DESIGN REVIEW COMMITTEE

February 5, 2015

STAFF REPORT AND FINDINGS OF FACT

SUBJECT: Design Review Request (DR15-01) by Christy Campbell to construct a single-family dwelling at 2830 Mill Pond Lane

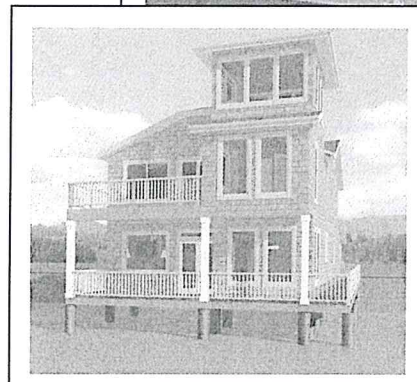
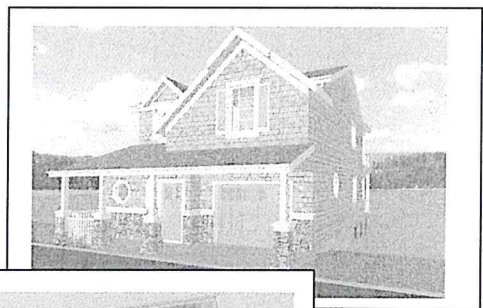
Finding: All windows are vinyl and are fixed or casement. The windows are mostly rectangular and vertical, single and paired. Windows have simulated multi-lite and large single lite designs and a round window on three elevations. All lites will need to be true divided or have external muntins. There are no blank walls.

The window divisions are proposed to have exterior muntins. The rear elevation has three large areas of windows of less than 50% of the facade. Window area does not exceed wall area. This guideline is met.

2. Windows and casings shall be installed so that the windows do not protrude beyond the casing; and so that the casing protrudes beyond the plane of the siding. Any windows with grids shall be true divided or shall have external grids.
3. Exterior light fixtures shall have subdued lighting.
4. Hardi-shingles shall be smooth, not wood textured.

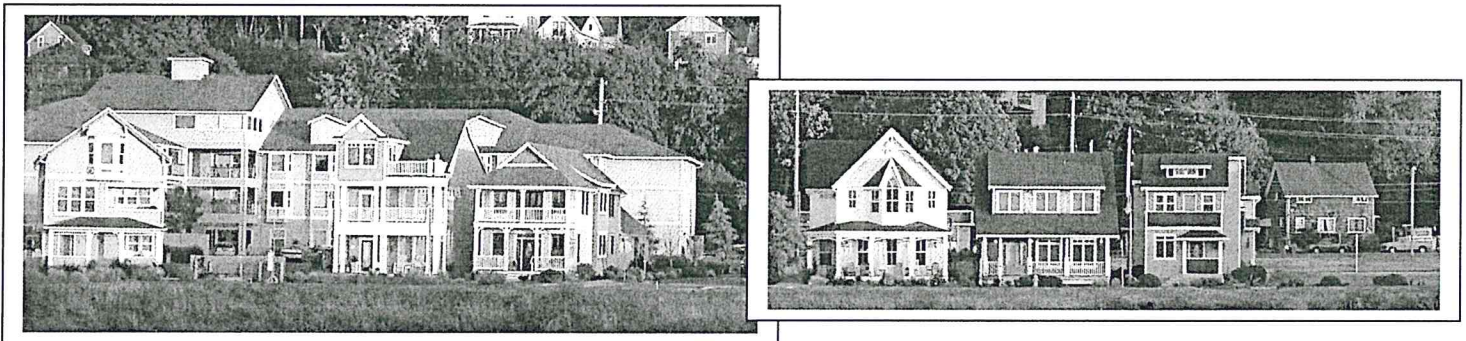
Finding: There are one, two, and three story residential buildings in the Uppertown area. Buildings in Mill Pond Village include one, two, 2.5, and three story structures. The proposed structure is 2 stories with a lookout structure. Structures in the Uppertown area have a mixture of wood, cement, and fiber cement siding. New residences in Mill Pond have a mixture of wood and fiber cement siding. The use of fiber cement shingles is characteristic of and harmonious with the buildings in the surrounding area and the character of the waterfront.
